# CITY OF NORTH LAS VEGAS

To: Bryan Saylor, Planner, Land Development & Community Services  
From: Jimmy Love, Major Projects Coordinator, Department of Public Works  
Subject: ZN-18-2024 **Ann & San Mateo-Bella Copia**  
Date: November 18, 2024

**RE: Ann & San Mateo, "Bella Copia"**  
**Letter of Intent – Comprehensive Plan Amendment (Land Use), Property Reclassification**  
**to PUD and Tentative Map**  
**APN: 124-30-414-001**

Sheet Number:  
**A2.1**

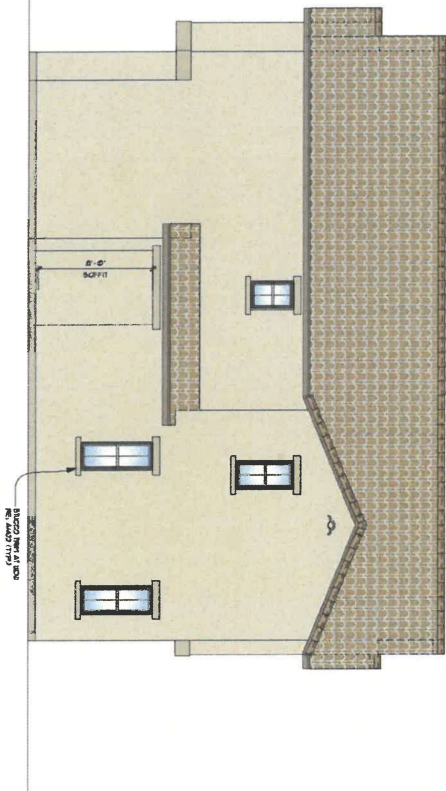
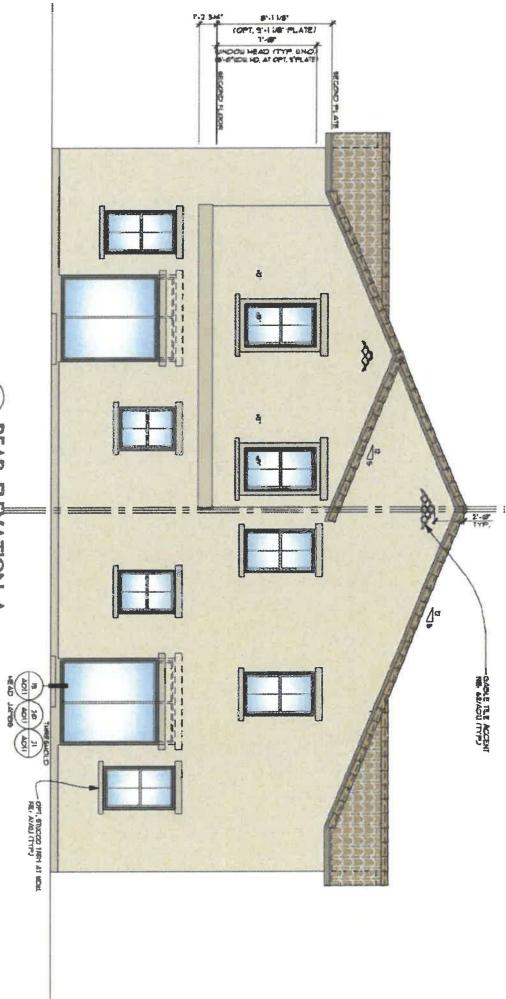
Complete a full structural  
analysis of the foundation  
and walls. The foundation  
and walls must be able to  
support the weight of the  
entire structure.
